AMENDMENT NO. 1 OCTOBER 1982

IS:2972(Part I)-1979 SPECIFICATION FOR TEXTILE MOTORS
PART I LOOM MOTORS

(First Revision)

3B Frame No. LL 112M to LL 132 M

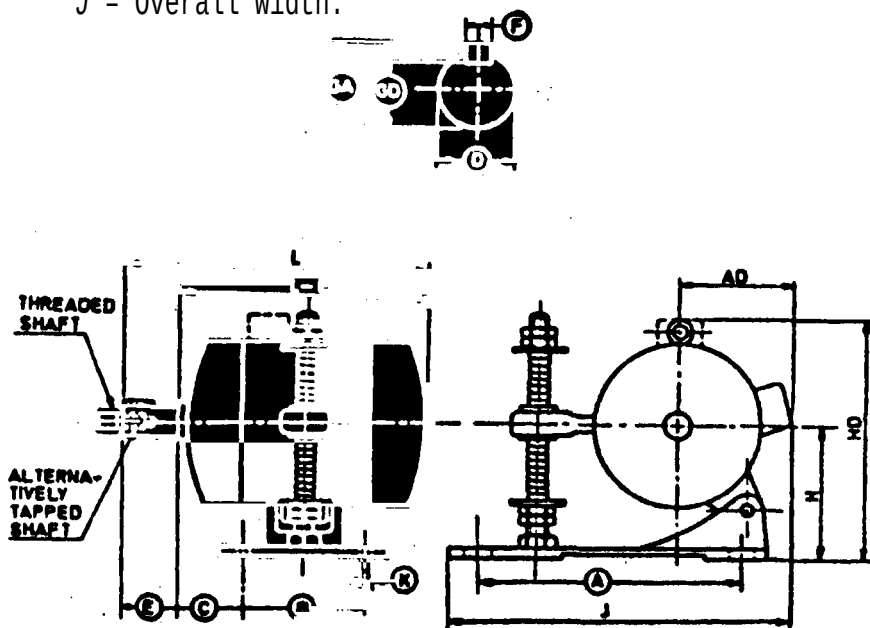
(Page 12, Fig. 3B)- Modify the arrow marks of
dimensions A and J to indicate:

A - Centre to centre distance between fixing holes.

J - Overall width.
